**From:** Labarba, Sam <[sam.labarba@dnr.ga.gov](mailto:sam.labarba@dnr.ga.gov)>  
**Sent:** Tuesday, November 5, 2019 4:21 PM  
**To:** DeMell, Mike J <[mdemell@ESINC.CC](mailto:mdemell@ESINC.CC)>  
**Subject:** RE: Hayler Dock Letter to CRD

Mark and Wendy Hayler, #5-7 Alley 3, Chatham 0711991\_120100AM

**Re: Application for a Coastal Marshlands Protection Act Permit for Mark & Wendy Hayler, Change of Use and Maintenance of an Existing Dock Facility, Tybee Creek, Chatham County, Georgia.**

PLAN & SECTION  
 GEORGE H. SPIRIDES  
 OCEAN FRONT & 15TH STREET  
 TYBEE ISLAND, GEORGIA 31328

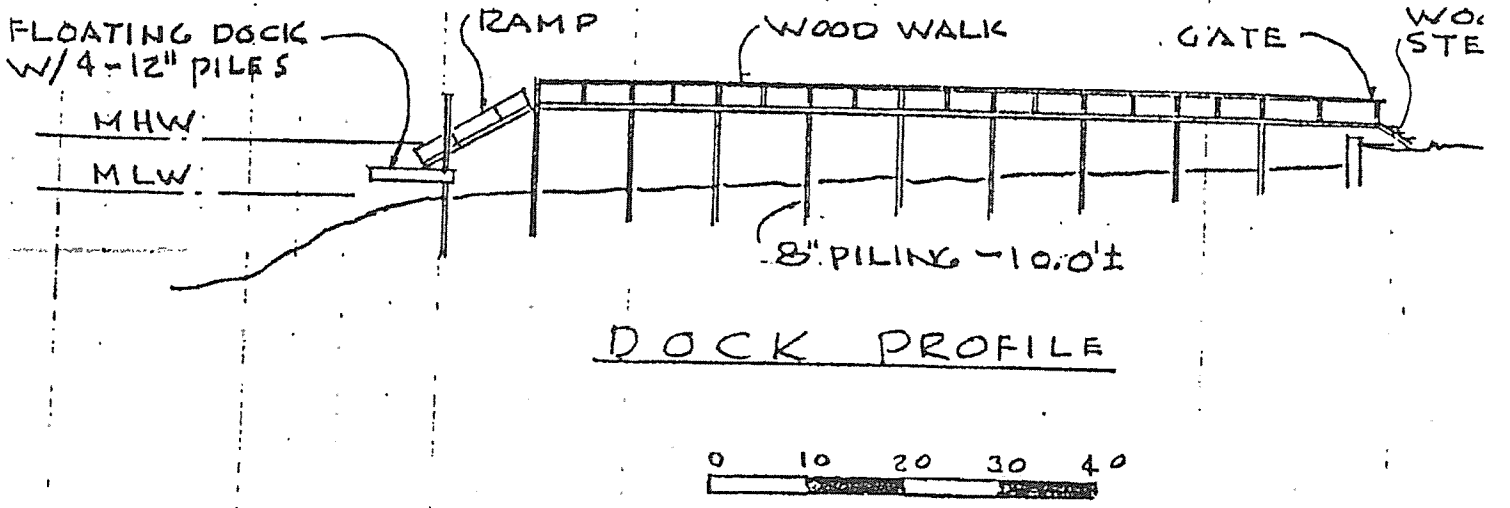
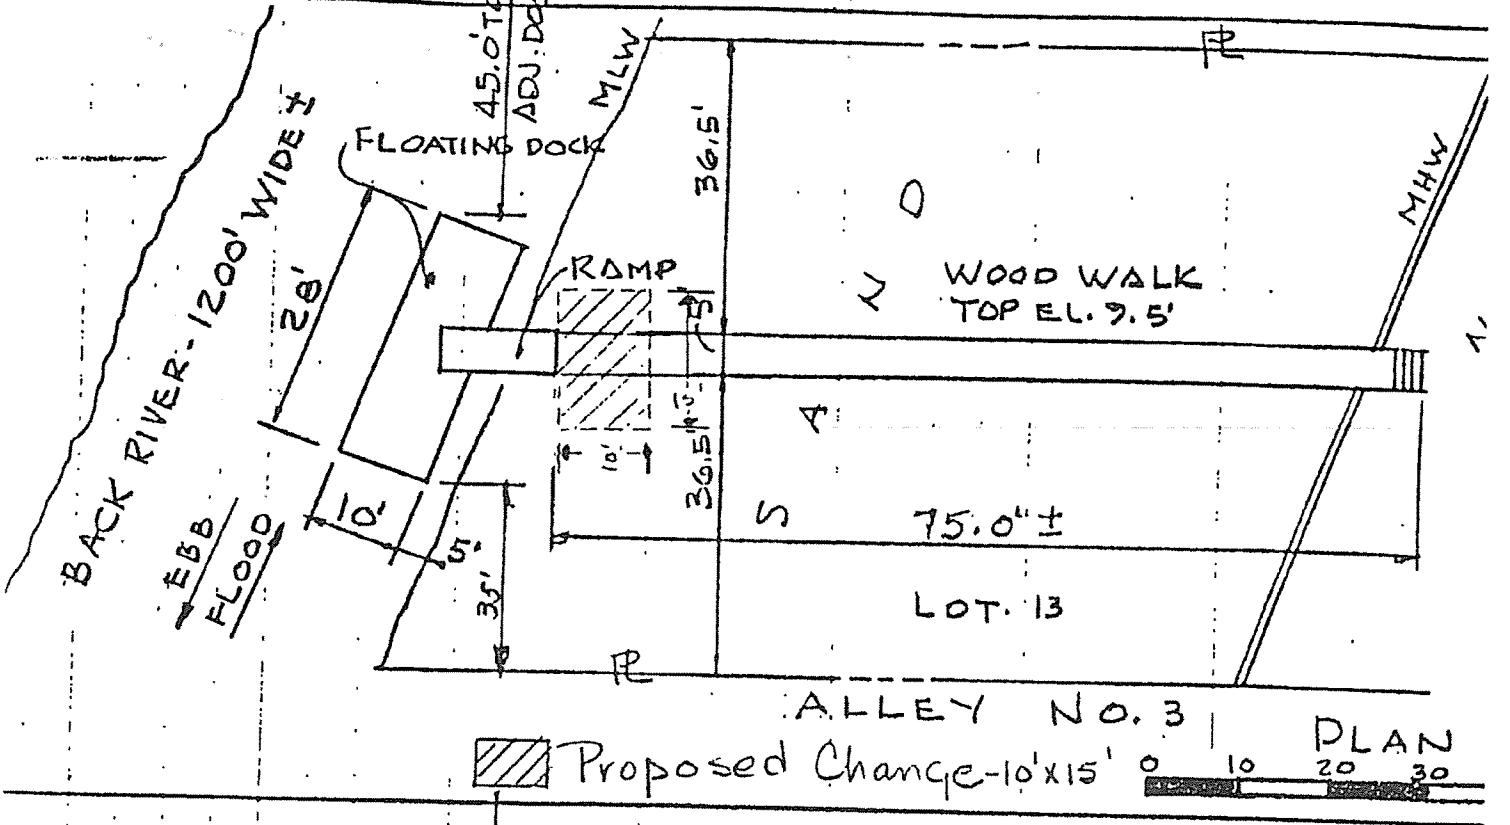
The dimensions of the fixed deck need to be included somewhere on this application. You can add it into the description or have the engineer update the drawing. Writing in on top of the engineered drawing will not be appropriate because it gives the impression that it was done professionally with the stamp and signature from the engineer. As long as the

A couple more things... The description says the walkway is 86ft. 10in. but the drawing shows 84ft. Can you explain this difference? (DeMell comment; the 84' measure is taken from the approximate drip line of the roof over the fixed deck. Placing a scale on the figure, beginning at the edge of the fixed deck to the NE end I measure slightly over 86'. Looking back at the description, Page 1, Section 1.1 Existing Conditions speaks to 86'-10".) Also, I just wanted to clarify the extended property line on the drawing. Is this the property line separating both sides of the duplex, or is it the property line to the neighboring home? (DeMell comment; The extension of the property boundaries are between the duplex property and the Alley Street boundary on the southeast and between the duplex property and the adjoining neighbor to the northwest.)

scale is correct and it is included in the description of the existing facility we should be okay. (DeMell comment; the drawings are to scale and the fixed deck measures out correctly. Additionally, this same measure is provided in the project description within the application materials we provided. Page 1, paragraph 2 of the description speaks to the fixed deck size.)
